Process Change Notification

PCN Number: PCN-2016-54

STATS ChipPAC* Assembly, Test and Final Pack Site Transfer from Shanghai to Jiangyin CHINA

Below is a 2D representative image of the Package: MF (Mark Format) = 246 Rev A

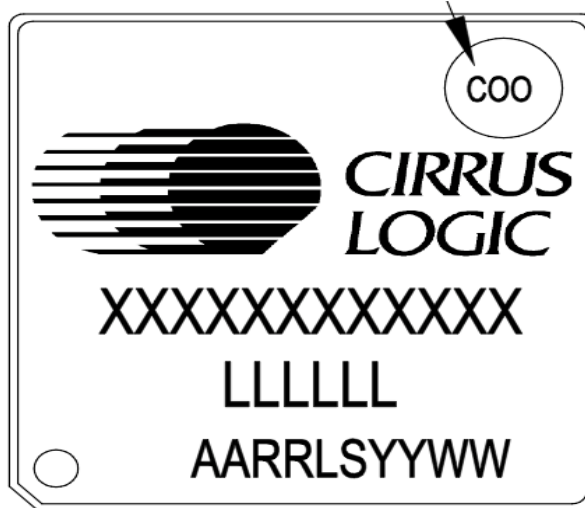
The Cirrus Logic component symbolization on the external face of the device reflects the designated Assembly Site location. The Assembly Site Code on the external face of the designated components will change. Specifically, the 1st two characters of the PackMark will change:

From: "BA"
 To: "BB"
 Note: All other symbolization will remain the same.
